## Technical Service Bulletin

<b>Topic</b>	37 Message in instrument cluster: "Drive system: fault. Please contact workshop", DTC B114E13 or B114F13 in DA 8119
<b>Market area</b>	United States 444 Volkswagen of America, Inc. (6444)
<b>Brand</b>	Audi
<b>Transaction No.</b>	2079294/1
<b>Level</b>	EH
<b>Status</b>	Released for publishing
<b>Release date</b>	Sep 23, 2025

37 Message in instrument cluster: "Drive system: fault. Please contact workshop", DTC B114E13 or B114F13 in DA 8119

**Figure 2.** *Correct wire routing on left side.*

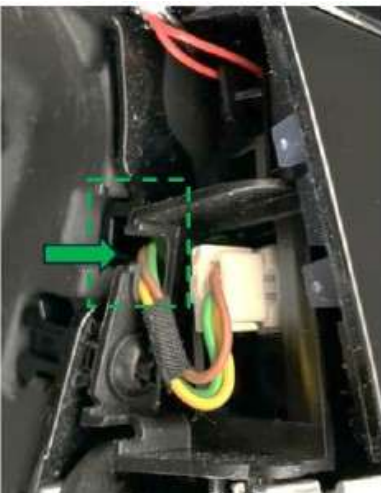
Incorrect wire routing in steering wheel and oversensitive diagnostic parameters in multifunction steering wheel control unit 3 -J453- (diagnostic address 8119).

Route the wires on the left and right sides of the steering wheel so that they are guided through the corresponding retaining lug (refer to Figures 2 and 3).

Unplug the connector and check the wiring harness for damage.

Reinstall the airbag unit as specified in the Workshop Manual and then erase the event memory entries for the vehicle as a whole. Then perform a road test of at least 10 miles and reassess the complaint.
